CBD and South East Light Rail Project – Submission to the EIS

Whilst these objectives were broadly met by the scheme approved on 4 June 2014 (as modified). UNSW has focussed its attention on its fundamental concern, staff and student safety, to ensure a consistent, but superior outcome may result, not only for its community, but also the wider community. Concerns remain and have been further identified following the review of the exhibited material of the State Significant Infrastructure Approval (SSI-6042), Modifications Report (MOD 4, dated November 2015).

Figure 2 – Likely unsafe cyclist manoeuvres [Source: TfNSW and UNSW]

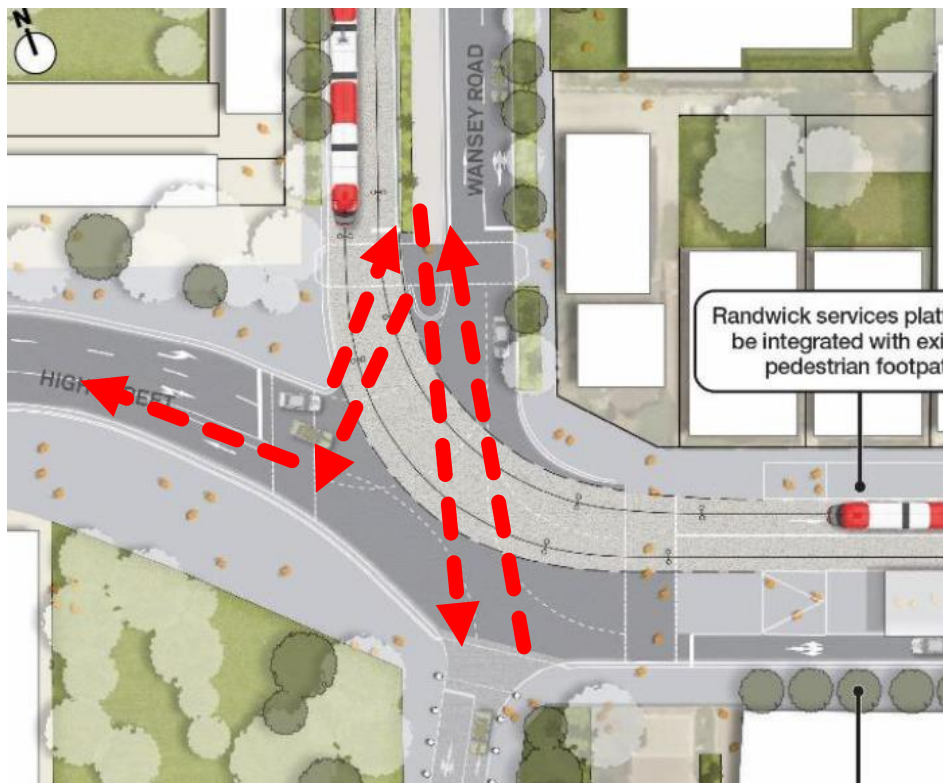
Concern is raised over the proposed cycle route interface at the intersection of Wansey Road and High Street. Given the design of intersection the Wansey Street southbound and northbound cyclists will move through corner across the curved tracks (as shown in Figure 2), increasing the likelihood of accidents to cyclists and affecting the safety of cyclists, pedestrians and motorists.

Given the likelihood of accidents to cyclists and impact to the safety of cyclists, pedestrians and motorists at this intersection it is recommended that mitigation measures be utilised at this intersection to ensure safety is maintained in the area, without impacting the amenity and flow of traffic or Light Rail Vehicle (LRV).

UNSW requests that TfNSW and Randwick City Council (RCC) develop a clear connection between Wansey Road and Botany Street so that Cyclists do not use High Street lanes or the rail alignment, to access the campus or when intending to travel further west of the High Street Stop.

Figure 3 – Reduced risk cyclist manoeuvres at the corner of High Street and Wansey Road [Source: UNSW]

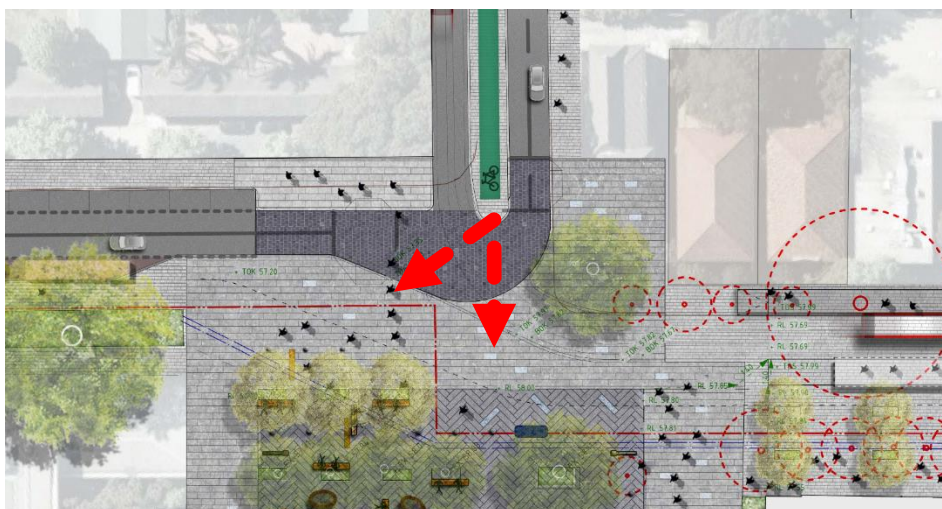
The UNSW proposal to fully pedestrianise High Street between Botany Street and Wansey Road is shown in **Figure 3** and indicates how pedestrian and cycle safety can be significantly improved by removing the west bound vehicle lane on the southern side of High Street.

Figure 4 Current and future sensitive environments within the Campus [Source: UNSW]

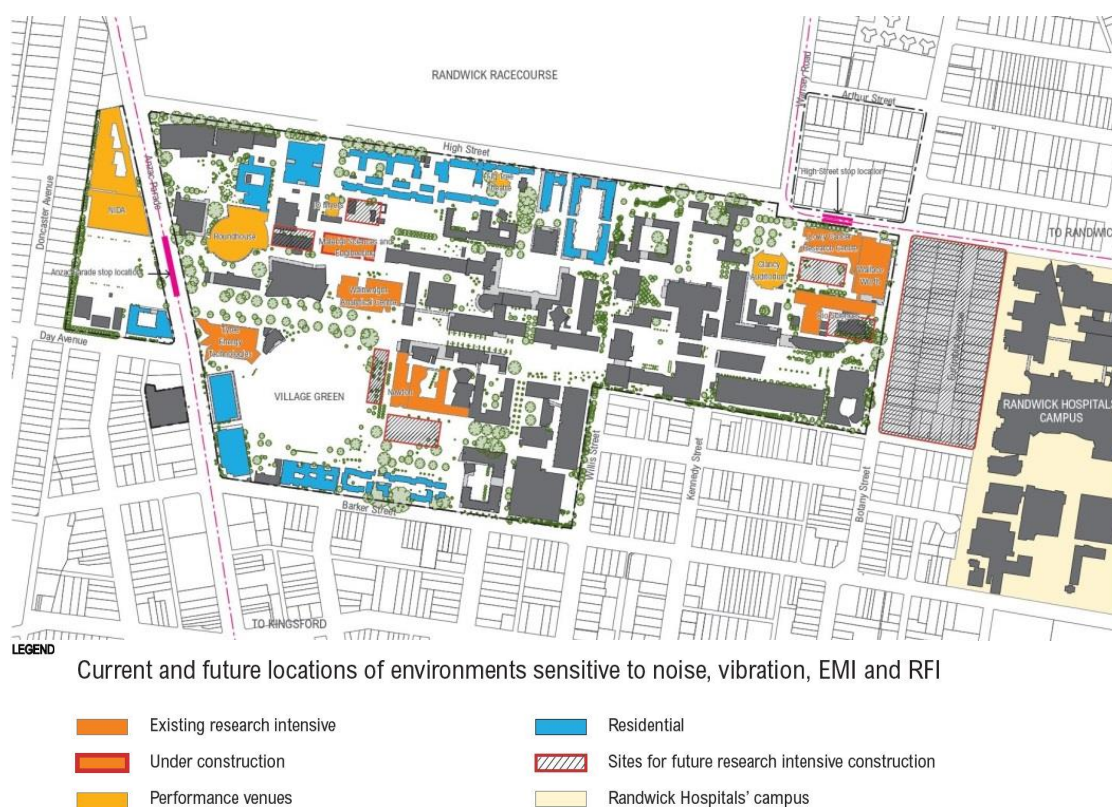
While the Lowy Building is stated in the reporting for Modification 4 as being a sensitive use, the Wallace Wurth Building is also sensitive (as identified in Figure 4) and consideration should be given to sensitive equipment such as Electron Microscopes and/or Animal Research Facilities, and the associated impact of the proposed on these.

Figure 6 – Existing and proposed bus stop locations [Source: UNSW]

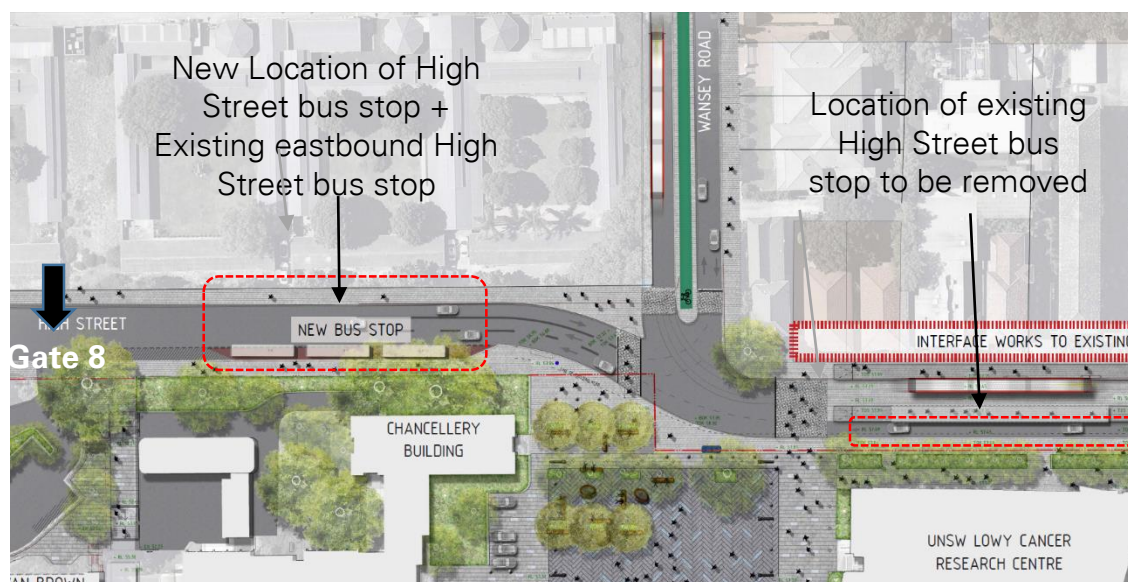
The existing UNSW bus stop currently located on the southern side of High Street on UNSW land (adjacent the Lowy Cancer Research Building) will need to be relocated as part of the proposed delivery of the High Street Stop (as shown on the Enhanced Scheme (Attachment A)). The proposed location for this stop is on the southern side of High Street, adjacent to the Chancellery Building near Gate 8 (approximately 150m west of the current location).

The proposed new bus stop, location, shelter design, size, and lighting needs to be developed in further detail with careful consideration of the existing Gate 8 bus stop on the opposite (northern) side of High Street. Consideration also needs to extend to the existing pedestrian crossing and Gate 8 entry pedestrians/vehicle entry to the Campus.

Figure 10 – Operating Frequency at opening year – Randwick and Kingsford Lines [Source: TfNSW]

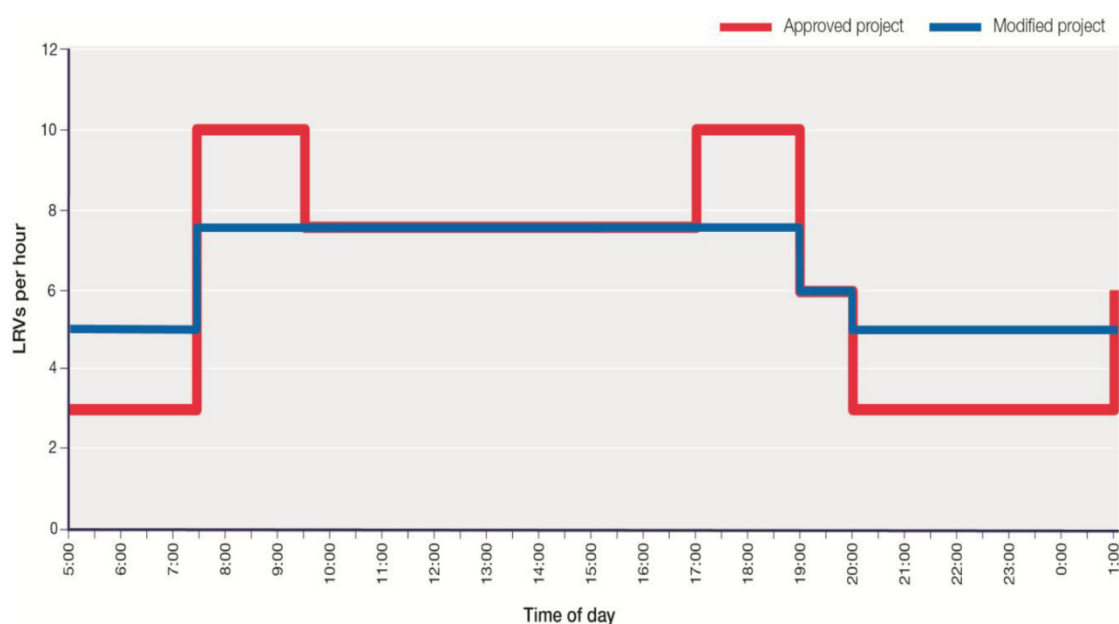
The approved change in LRV capacity (from 300 to 466) and change in peak hour service frequency (from 10 vehicles per hour to less than 8vph at opening (2021)) (see Figure 10) will significantly affect the patronage of the UNSW stops at High Street (and Anzac Parade). Importantly, further consideration of the impacts of the proposed modification on the operation of the two stops (generally improvements), particularly with regard to platform capacity, level of service, and pedestrian safety.

Based on the detail provided by TfNSW, it is understood that the Project will commence operations in 2019, while the future service frequencies may not be implemented until 2029, ten years after opening if at all.
